Aircraft Make *SGS* Model *1-26 F* Reg. No. *N33917* Serial No. *637*

Bulletin No. SA-006
Date: 1 March 1989
Page 1 of 1

SUBJECT: Replacement of Seat Back Adjustment Bracket

MODELS AFFECTED: All SGS 1-26D and SGS 1-26E

SEAT ADJUSTMENT BRACKET

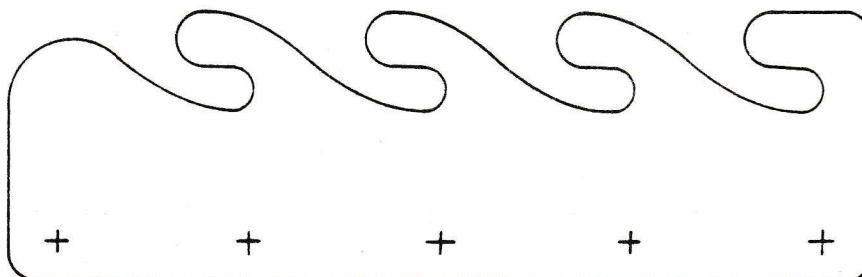
PREFACE: Reports indicate that on the affected aircraft, the pilot's seat back could inadvertently slide back during tow, when experiencing turbulence or during certain flight attitudes where a negative g condition may exist.

A new bracket, (PN26245D-3), and spacer, (PN26245D-5), has been designed to resolve this problem. This service bulletin lists instructions to install this improved seat back adjustment bracket. This improved bracket should reduce the possibility of sudden seat back movement.

- Drill out rivets securing existing seat adjustment brackets. Remove brackets.
- Clean up bracket mount area removing any burrs and sharp edges.
- Paint bracket mount areas with a thin coat of Zinc Chromate or equivalent primer to prevent corrosion.
- Place the spacer between the inside fuselage wall and the lower edge of bracket.
- Mark the mount area and drill holes as per old bracket using a #30 drill bit and secure with Cleco.
- Install rivets (MS20426AD4) (5) places on each bracket and spacer kit.
- Paint exterior of rivet heads.
- Record compliance with this service bulletin in the aircraft log book.

FIGURE 1. ENGAGEMENT OF TOW HOOK INTO RELEASE ARM

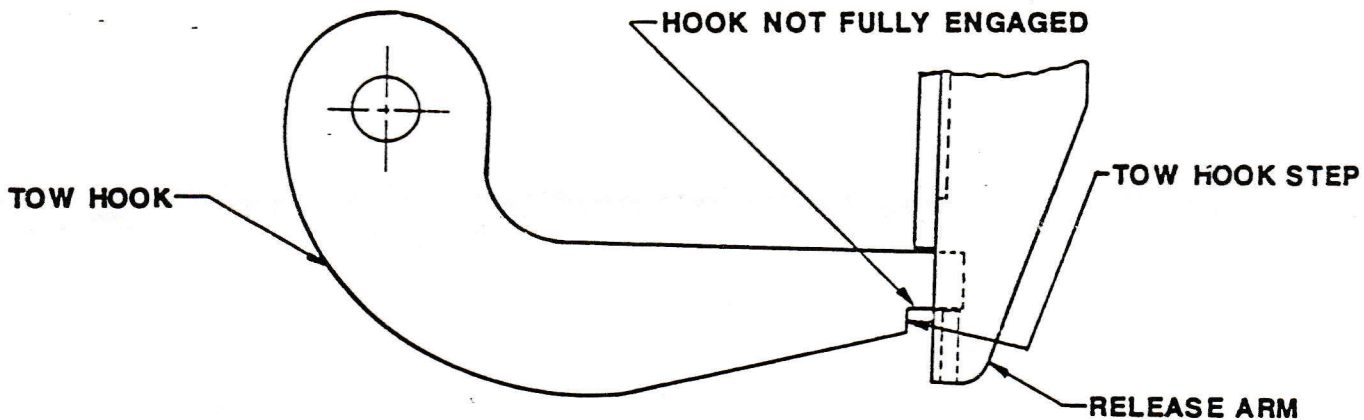
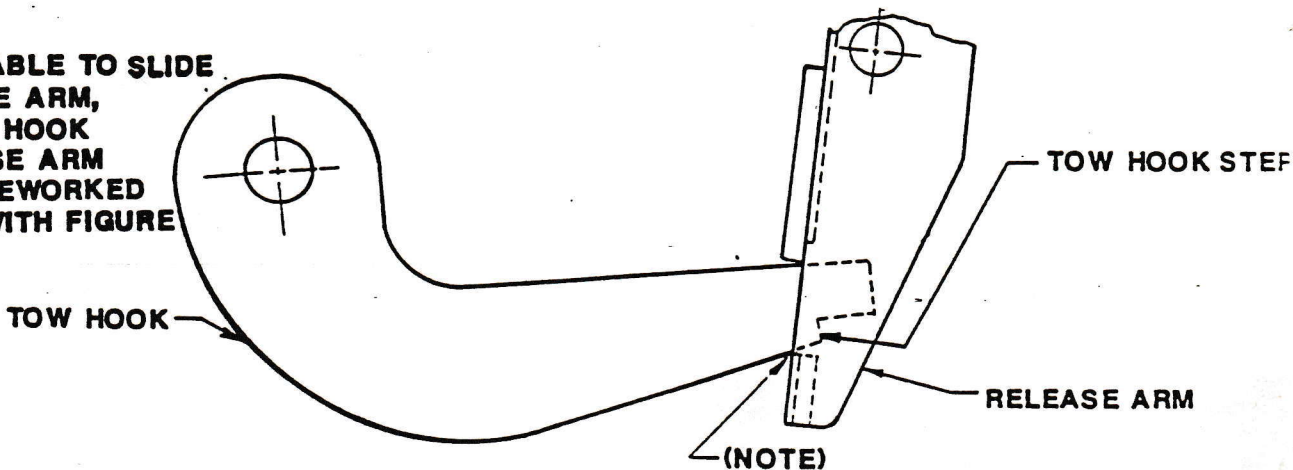
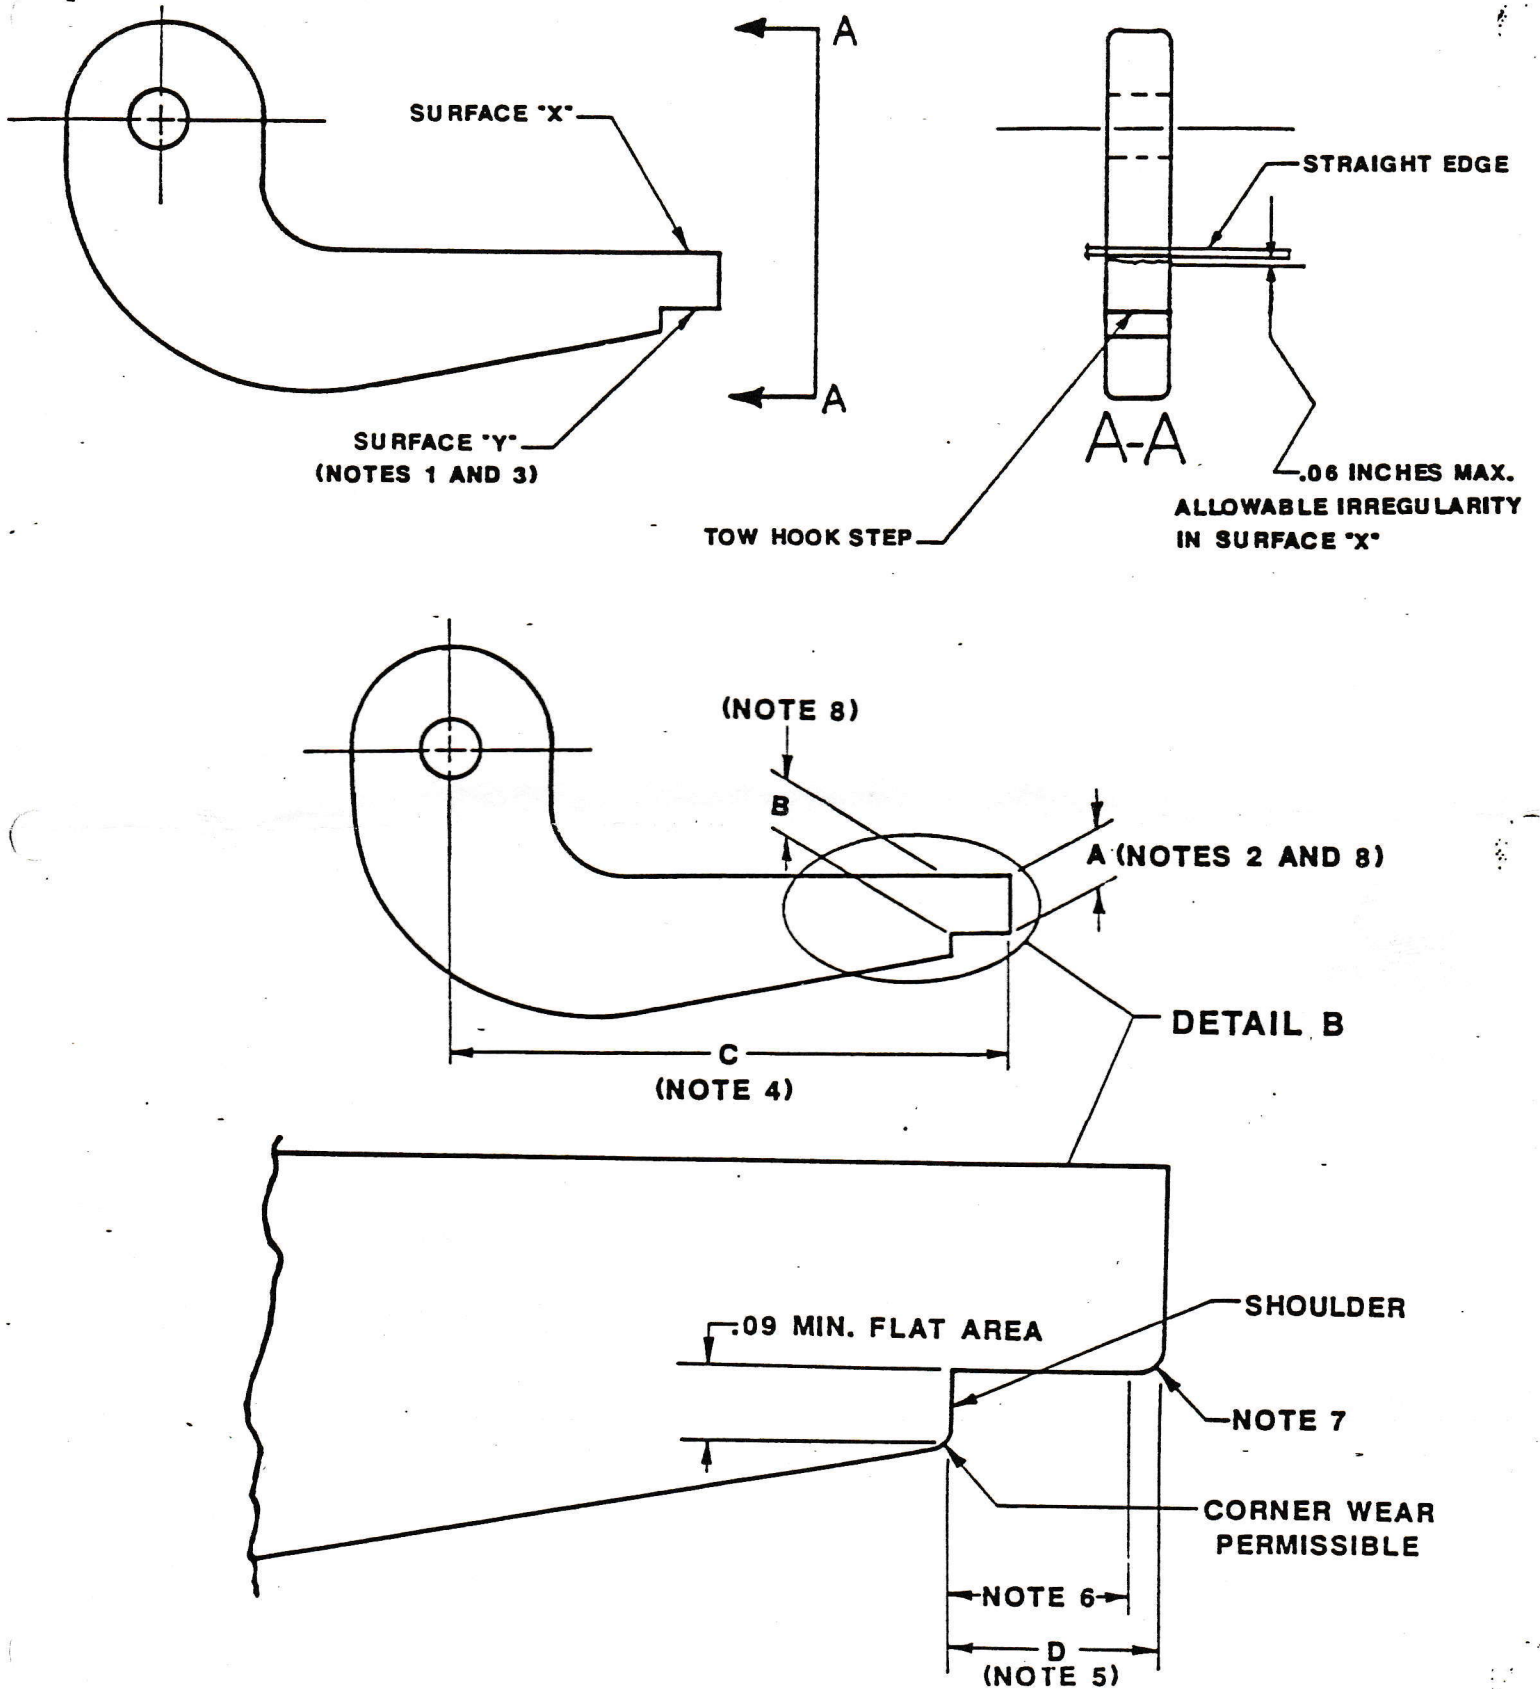
- Figure 1 shows proper attachment of the tow hook into the release arm. Note that the step of the tow hook should seat against the release arm. The tow hook step must fully engage the release arm to allow the release assembly to function properly. The tow hook must not be allowed to extend through the release arm beyond the step on the hook as shown in Figure 1, View C.

IF TOW HOOK IS ABLE TO SLIDE THROUGH RELEASE ARM, BEYOND THE TOW HOOK STEP, THE RELEASE ARM MUST EITHER BE REWORKED IN ACCORDANCE WITH FIGURE 3, OR REPLACED.

- g. If tow hook is able to travel too far inboard as shown in Figure 1, View C, disengage tow hook from release arm and measure the length of the release arm slot.
- h. If dimension is less than 0.66 inch, rework release arm by welding on 1B-217-19 slug at location shown in Figure 3. (Release arm may be replaced as an alternate to welding on slug.)
- i. If length of release arm slot is greater than 0.66 inch, replace release arm.
- j. Perform a thorough inspection of the tow hook installation in accordance with the 100 hour inspection requirements listed in Table 2 of this bulletin.
- k. Repair or replace unserviceable component(s), as required.
- l. Record compliance with Part I of this Service Bulletin in Aircraft Log Book.

FIGURE 2. TOW HOOK INSPECTION AND REWORK (SHEET 1 OF 2)

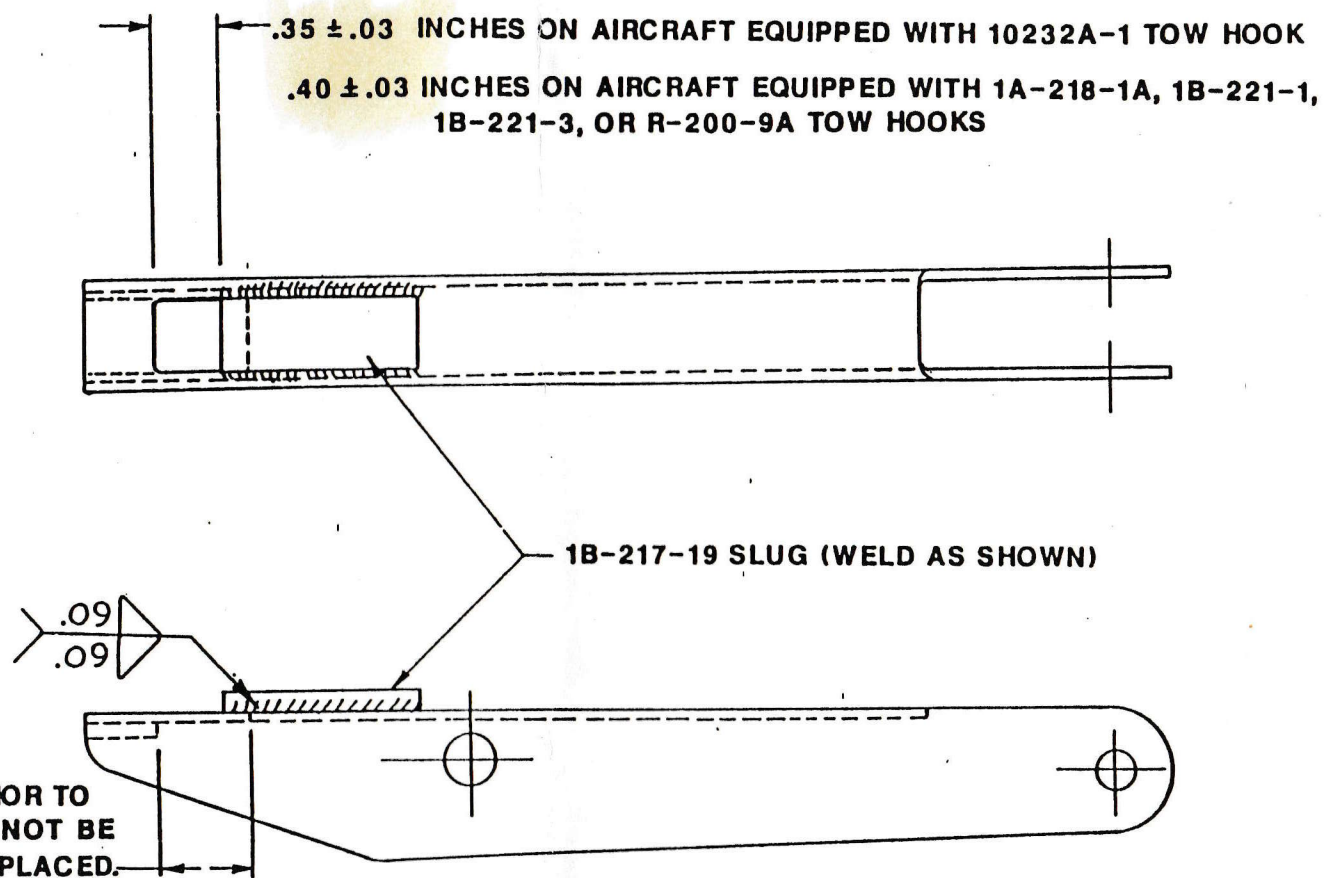
1. IF WEAR OCCURS ON SURFACE "Y" IT MUST BE POLISHED FLAT WITHIN TOLERANCES PROVIDED IN FIGURE 2 (SHEET 1). IF THE HOOK CANNOT MEET THESE REQUIRED DIMENSIONS IT MUST BE REPLACED. UNDER NO CONDITIONS SHOULD SURFACE "X" BE POLISHED OR MACHINED TO CHANGE ITS ANGLE.

3. SURFACE "Y" MUST REMAIN FLAT, SMOOTH, AND WITHIN TOLERANCES SHOWN ON SHEET 1. (SEE ILLUSTRATION.)
4. DIMENSION "C" ON 10232A-1 HOOK SHALL BE $2.06 \pm .03$ INCHES. DIMENSION "C" ON 1A-218-1A, 1B-221-1, 1B-221-3, & R-200-9A SHALL BE $3.00 \pm .03$ INCHES.

- d. If tow hook dimensions are not within limits specified in Figure 2, either rework the tow hook to obtain dimensions (as specified in Figure 2) or replace it with a new or serviceable, used tow hook.
- e. Engage tow hook into release arm. Ensure that the tow hook engages properly as shown in Figure 1, View A.
- f. If tow hook is unable to completely engage (shown by Figure 1, View B), shorten the rubber bumper stop between the release knob and the instrument panel to allow the release assembly to close further.

FIGURE 1

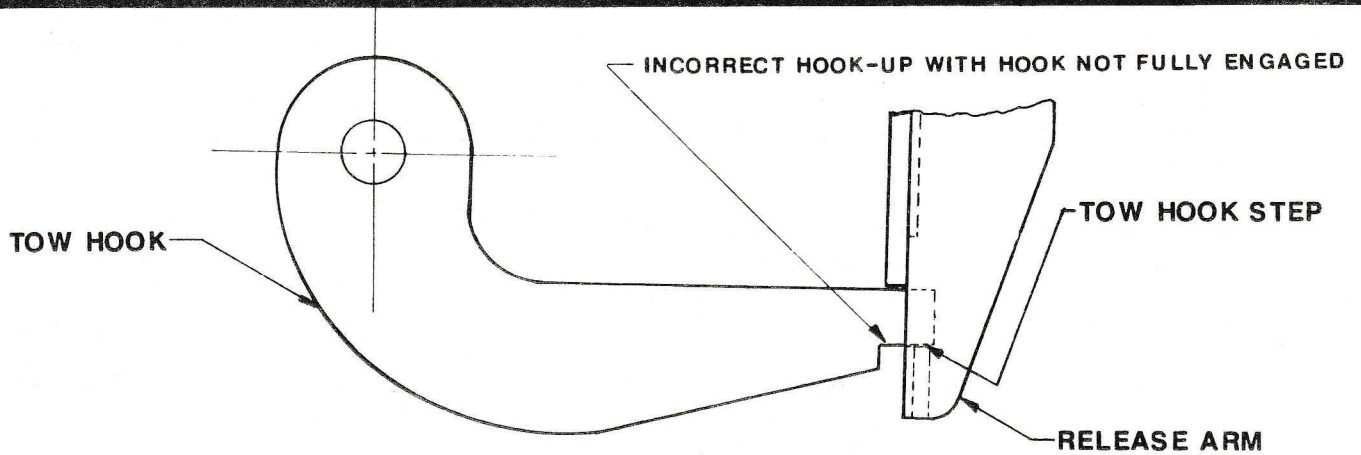
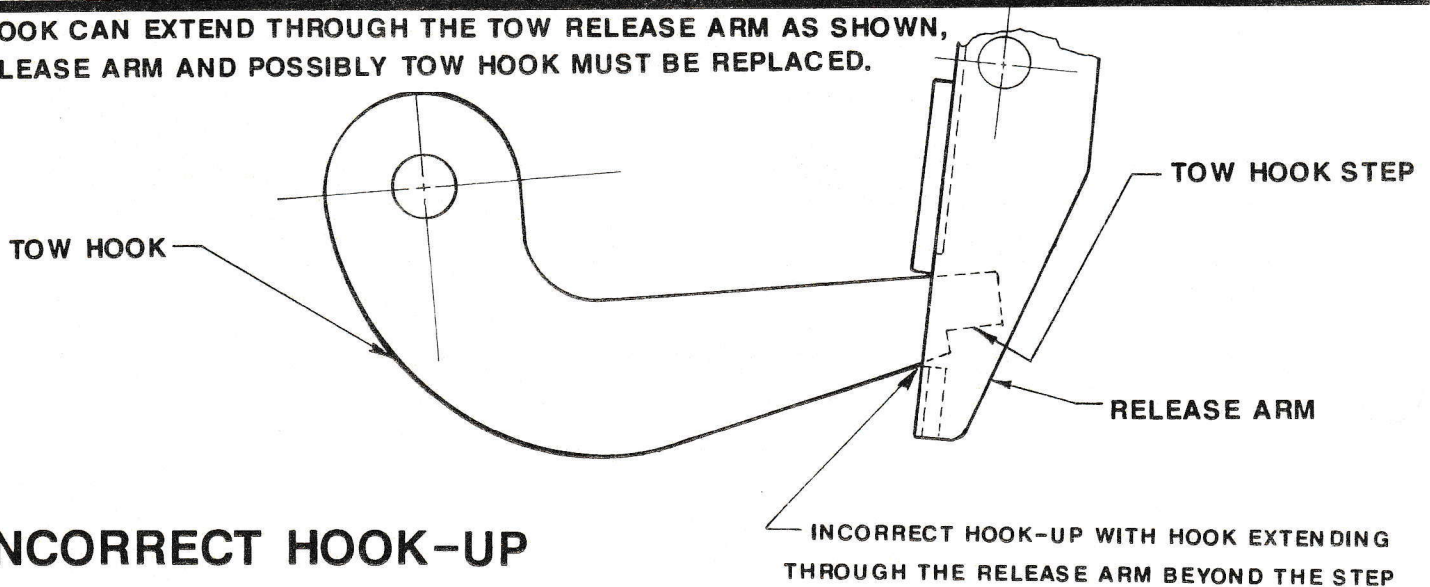
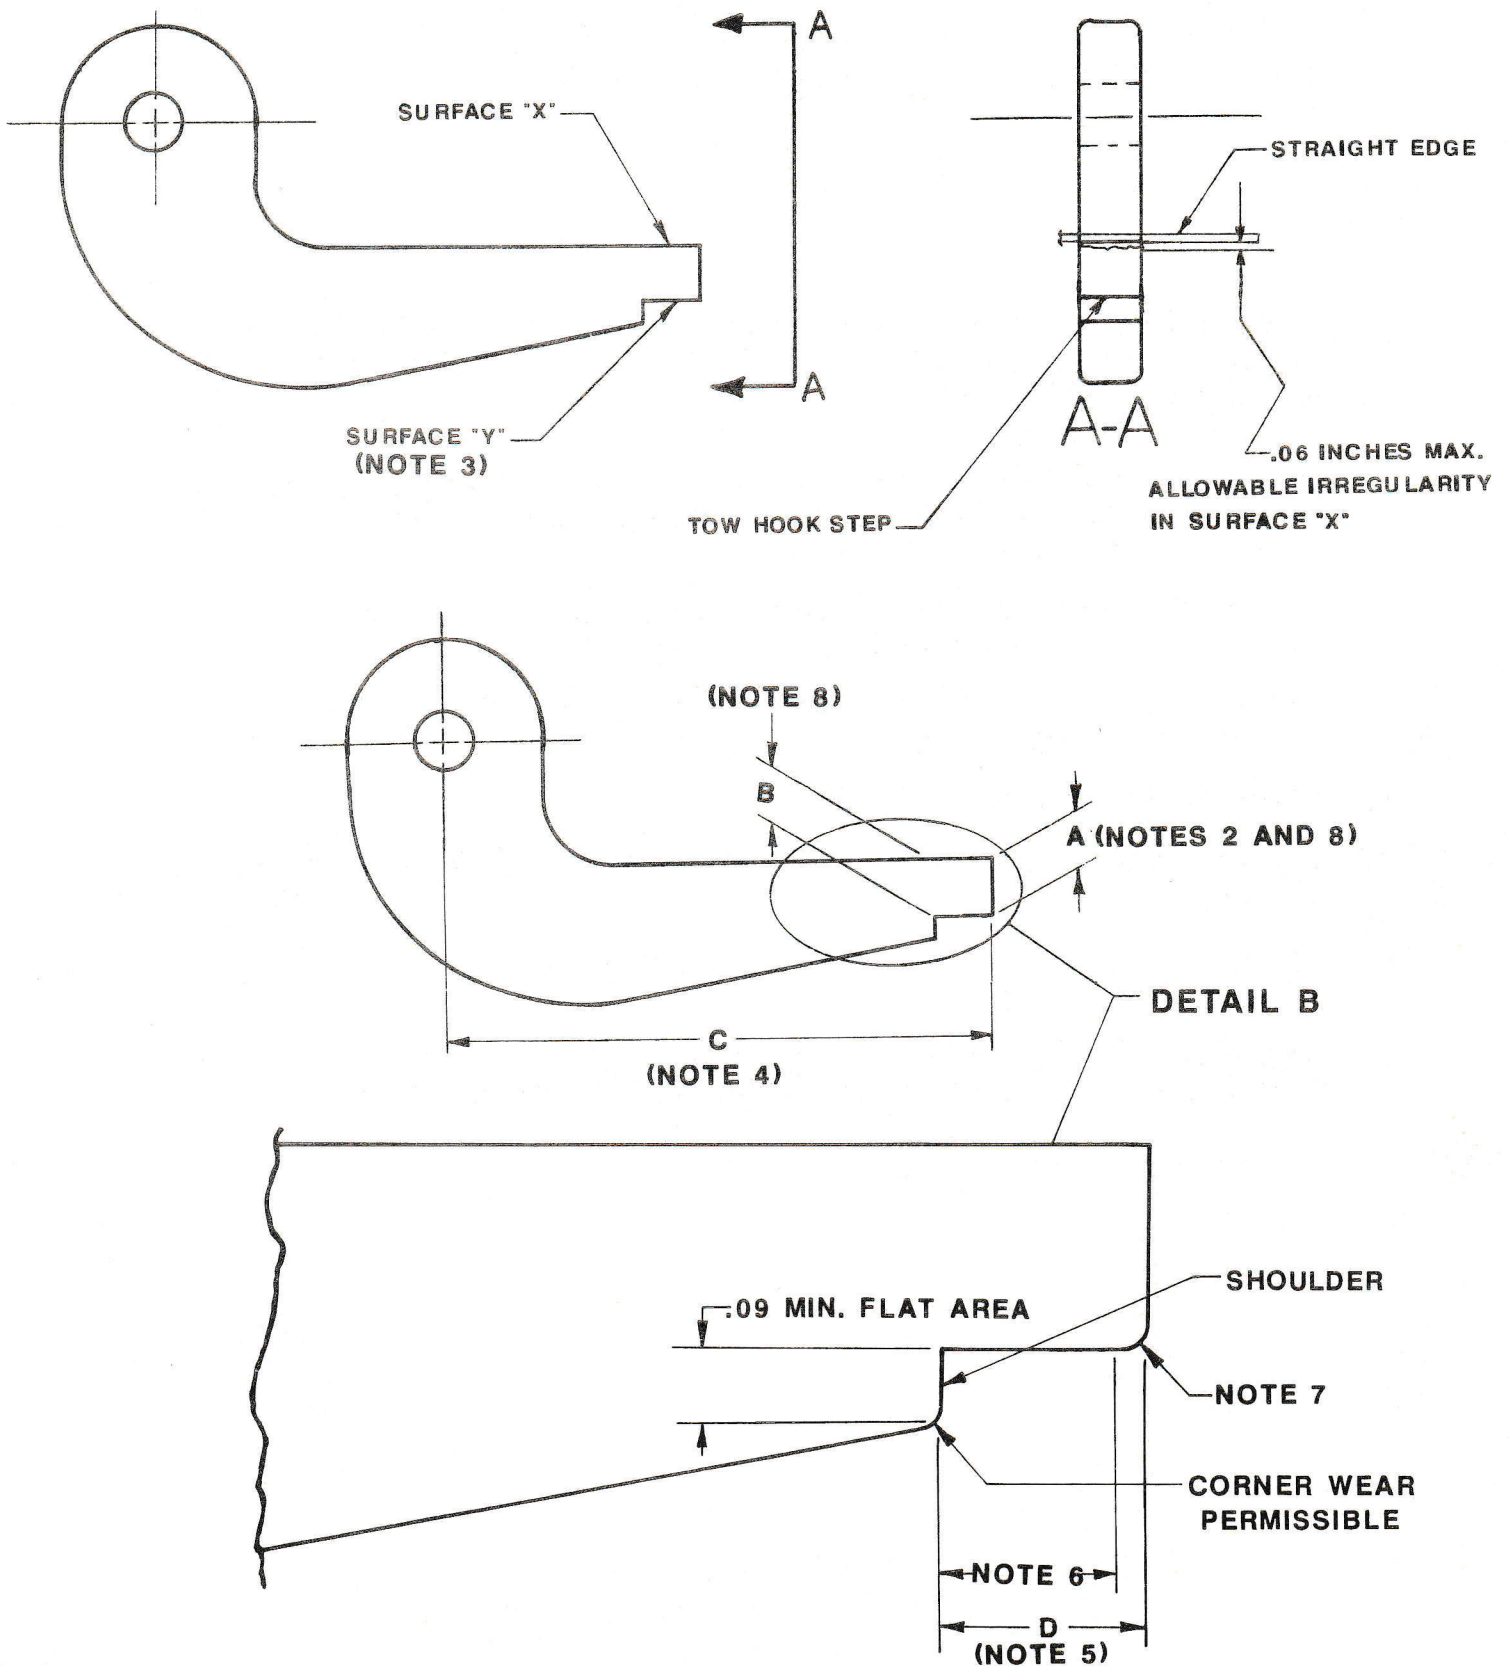
Figure 1 shows the positions for the tow hook and release arm when correctly hooked-up. Note that the step of the tow hook should be tight against the release arm assembly. The tow hook step must fully engage the release arm to allow the release assembly to work properly. The tow hook must not be allowed to extend through the release arm beyond the step on the hook since this creates a condition which defeats the design of the release and increases the possibility of an inadvertent release.

Tow hook must engage release arm in accordance with Figure 1A & Figure 4. If hook is able to pass through release arm beyond step as shown in Figure 1C, release arm and/or hook must be reworked with slug or replaced.

If tow hook fails to engage completely as shown in Figure 1B, check release control rigging. Shortening the rubber bumper stop between the release knob and instrument panel will allow the release assembly to close further.

IF TOW HOOK CAN EXTEND THROUGH THE TOW RELEASE ARM AS SHOWN, RELEASE ARM AND POSSIBLY TOW HOOK MUST BE REPLACED.
